Fig.3B

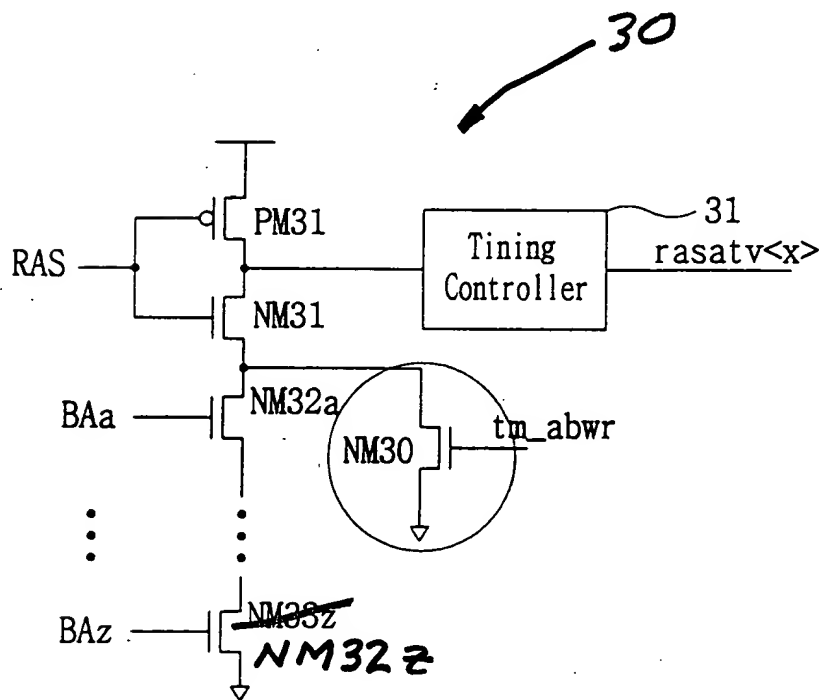
The proposed corrections to the drawing of Fig. 3B adds reference numeral --30-; and corrects a typographical error changing "NM33z" to --NM32z--. Support for the first proposed correction is found at page 6, line 20, of the specification. Support for the second proposed correction is found at page 6, line 28, of the specification.

Fig. fig.4B

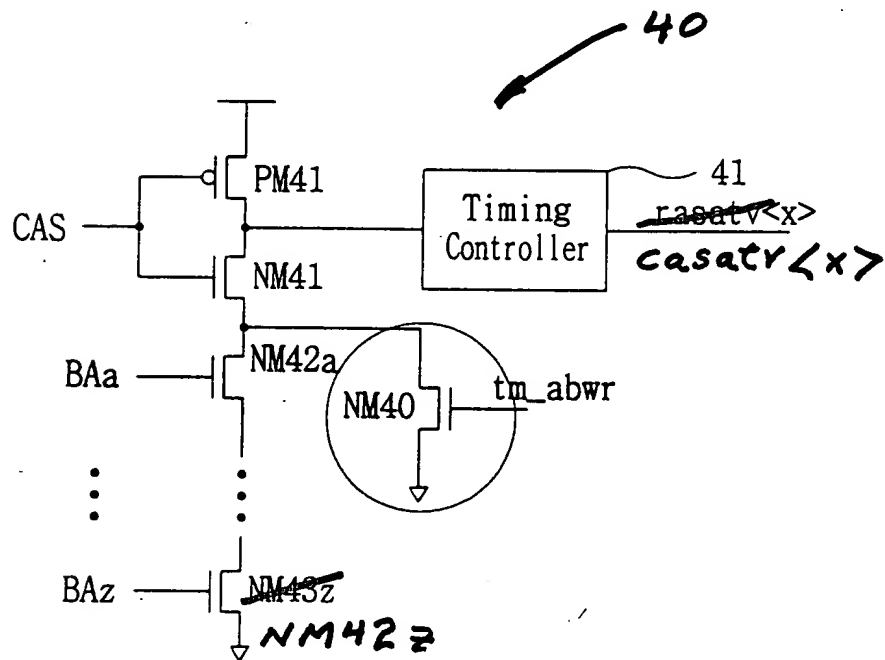
The proposed corrections to the drawing of Fig. 4B adds reference numeral --40-; and corrects a typographical error changing "NM43z" to --NM42z--. Support for the first proposed correction is found at page 7, lines 9-10, of the specification. Support for the second proposed correction is found at page 7, line 19, of the specification.

Fig. 7

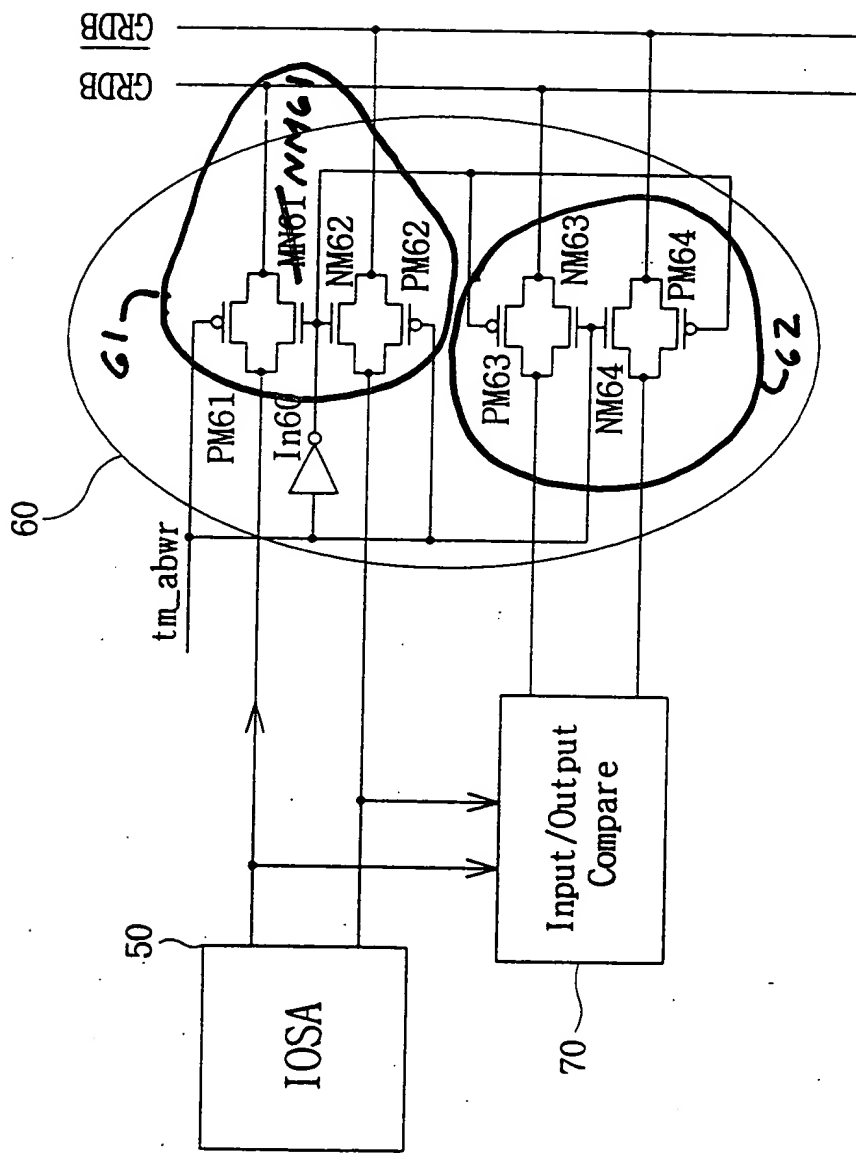
The proposed corrections to the drawing of Fig. 7 are to correct typographical errors relating to NMOS transistor NM61; and

to identify those aspects of Fig. 7 which comprise elements 61 and 62. Support for changing "MN61" to --NM61-- is found at page 8, line 18, of the specification. Support for adding reference numeral --61-- is found at page 8, line 17, through page 9, line 1, of the specification. Support for adding reference numeral --62-- is found at page 9, lines 2-15, of the specification.
